**Report: Punch List**  
**Function: Test, Adjust, & Balance**  
**Date: 12/09/2025**  
**Completed By: National TAB**

**PROJECT**  
**12-08-25 FREDDYS MIDDLETOWN, DE**

- RTU 1 low flow

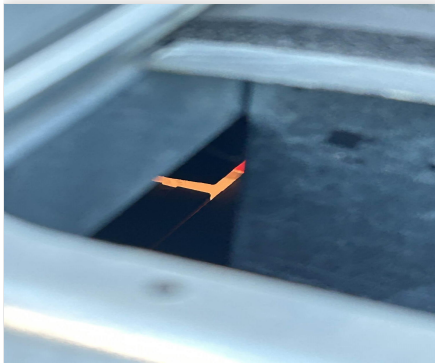
**Issue Name :** RTU 1 low flow  
**Description :** RTU 1 supply drop has a 4" opening and is not properly attached to discharge. Unit is losing air inside the ceiling. Unable to properly balance.  
**Created By :** National TAB                      **Assigned To :** National TAB - Dan Hertenstein  
**Status :** Open  
**Priority :** Urgent                                      **Asset Tag :** RTU1  
**Originated Date :** 12/09/2025 - Jearod Ferrette - National TAB
